RS-15-255

R. E. Ginna Nuclear Power Plant  
Renewed Facility Operating License No. DPR-18  
NRC Docket No. 50-244

Subject: Response to NRC Audit Review Request for Additional Information Regarding  
Fukushima Lessons Learned - Flood Hazard Reevaluation Report

**Response to NRC Audit Review Request for Additional Information Regarding  
Fukushima Lessons Learned - Flood Hazard Reevaluation Report**

Figure 2-1: Ginna Site Layout

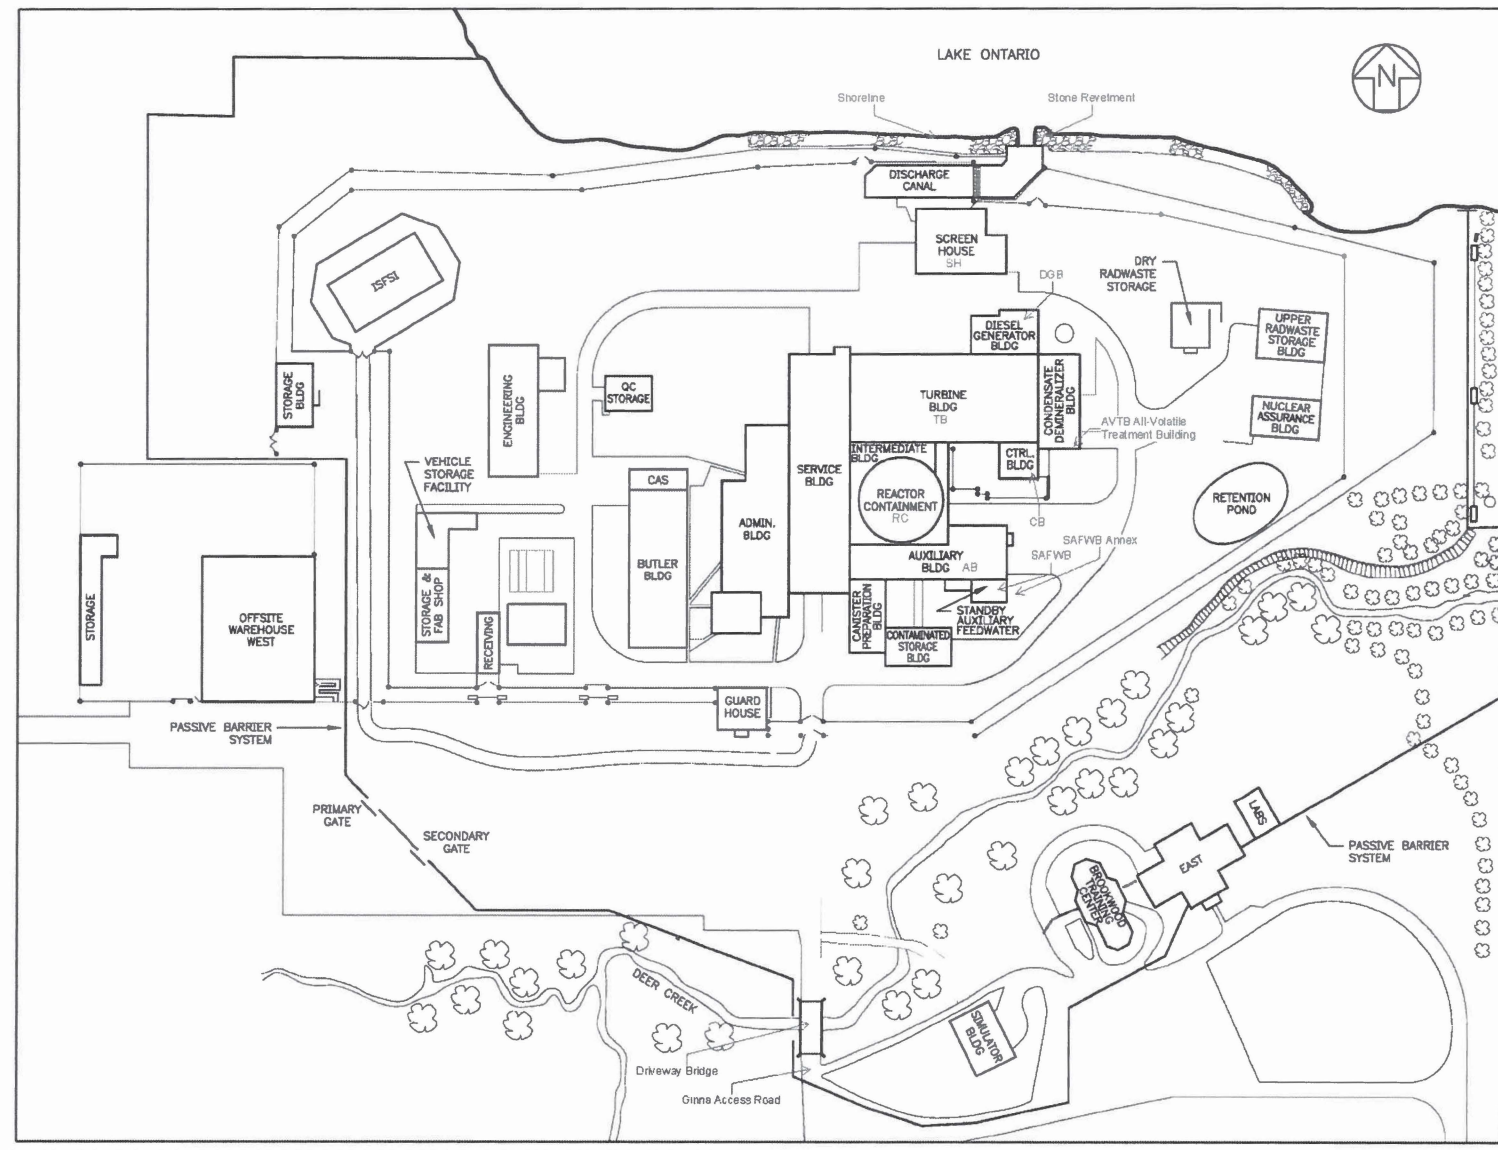
**Request:** *Describe the buildings and site feature locations discussed in the FHRR. Figure 1.2-1 could be modified or additional similar figures provided to illustrate the location of the structures listed in Table 1 to Table 4 of Enclosure 1 “Flood Hazard Reevaluation Tables for Flood-Causing Mechanism and Combined-Effects Floods Not Bound by the Reevaluated Hazard”, RC, TB, CB, SH, and DGBs, AB, AVTB, SAFWB, SAFWB Annex, Canister Preparation Building, Contaminated Storage Building, and the (“shoreline” or “stone” revetment), Ginna Access Road (and Culverts) and Driveway Bridge.*

Please see Figure 2-1 (revised from FHRR Figure 1.2-1) for locations of buildings identified in Table 1 through Table 4 of Enclosure 1.

Culverts were assumed to be non-functional during the FHRR flood mechanisms, and as a result were not identified in any drawings provided with the FHRR.

Figure showing vegetation areas surrounding the plant with recent aerial photograph.

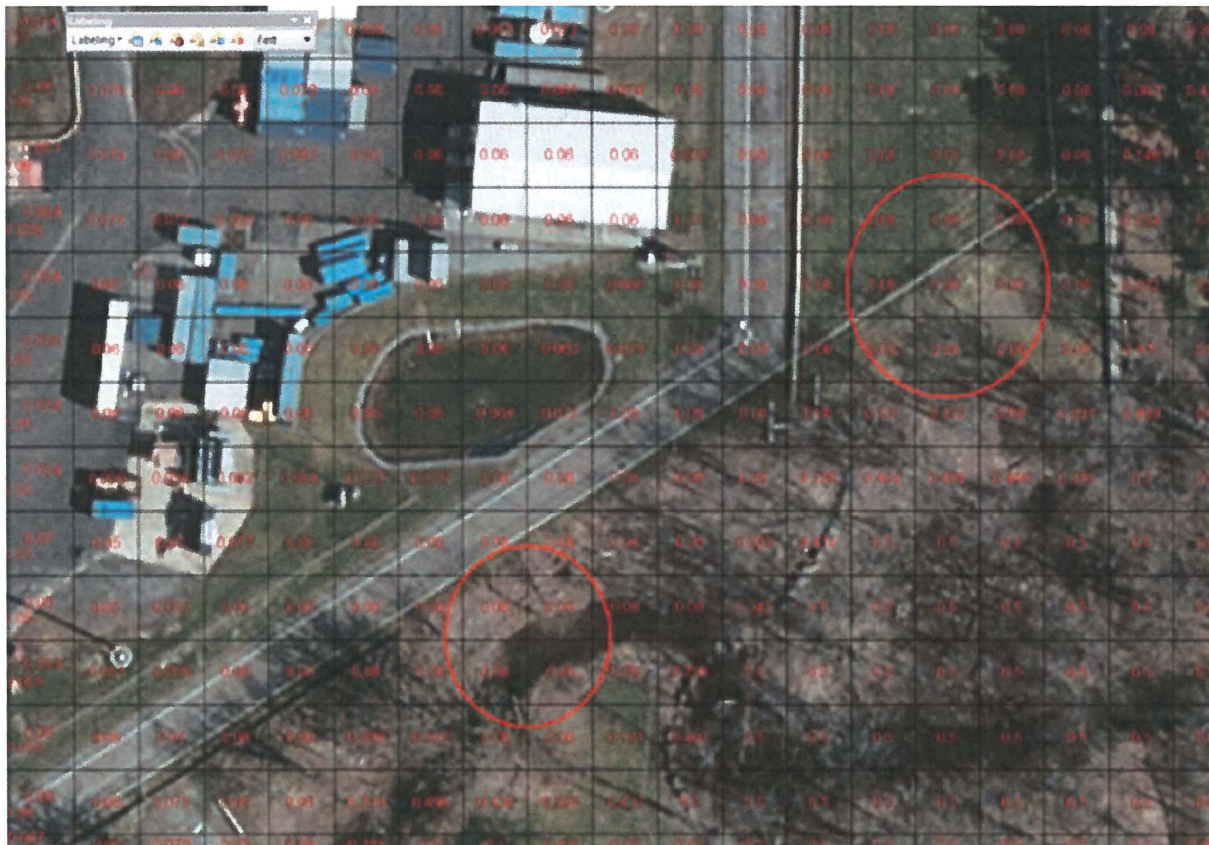
**Background:** FLO-2D simulated water depth due to stream flooding. The staff evaluated Manning's  $n$  values assigned in the FLO-2D in a same way described in Information Need 4 and noticed that several cells'  $n$  values for shrubs or grass are considered very low, i.e., 0.08. These areas (see figure in Information Need 4) are along the pathway that slowdown the stream overflow from southwest to northeast based on the velocity vector plot.

**Request:** Describe the justification of  $n$  values assigned for vegetation areas surrounding the plant (not just circled examples below in the figure) especially areas near the plant and structures.

Selected Manning's  $n$  values for the area in question of 0.08 are conservative for shrub and grass areas. The range of Manning's  $n$  values for floodplain areas of brush and light tree cover (in summer) is between 0.04 and 0.08, with a normal value of 0.06 (Chow, 1959). The Manning's  $n$ -value of 0.08, used in the PMF reevaluation analysis at Ginna (AREVA, 2013) is reasonable for varying land cover consisting of grass, brush and small areas of trees. The area of interest is shown in Figure 4-1.

A review of the selected Manning's n-values for the Ginna PMF reevaluation was performed. Figure 4-2 presents an overlay of the Manning's n-value shapefile used in the reevaluation calculation and an orthophotograph of the site area. The map shows the assigned Manning's n-values for each land use classification. The land use class definitions are included as Table 4-1. It is acknowledged that the NLCD dataset used as a source for delineating land use classification is somewhat coarse relative to small-scale variation in land cover apparent in the orthophotographs. However, the assigned land use classes appear to reasonably represent the apparent land use classes at the site based on the orthophotograph.

A map showing an overlay of the FLO-2D predicted flood depths and the assigned (specified) Manning's n-values is included as Figure 4-3. This map indicates that flood depths in the area in question (area with a Manning's n value of 0.08 on the southeastern end of the plant) are generally between 5 and 23 feet. Surface roughness in this area is completely submerged (FLO-2D, 2012b) during the PMF, indicating that the use of the upper end of the Manning's n range for the land cover type of "light brush and trees, in summer" (0.040 to 0.080) in Chow, 1959 is conservative. The value of 0.080 is also in the upper end of the recommended range in HEC-RAS 2D for non-shallow flow conditions and land cover types of pervious areas, minimal (grassed) to thick (trees) vegetation (0.030 to 0.120). This composite land cover is representative of the area in question. Other areas with deep flows during the PMF, including the area south of the creek, were assigned the FLO-2D recommended higher Manning's n values.

In conclusion, the Manning n-values assigned in the FLO-2D model are judged to be appropriate for the existing land cover and modeled PMF flow depths with a reasonable degree of conservatism.
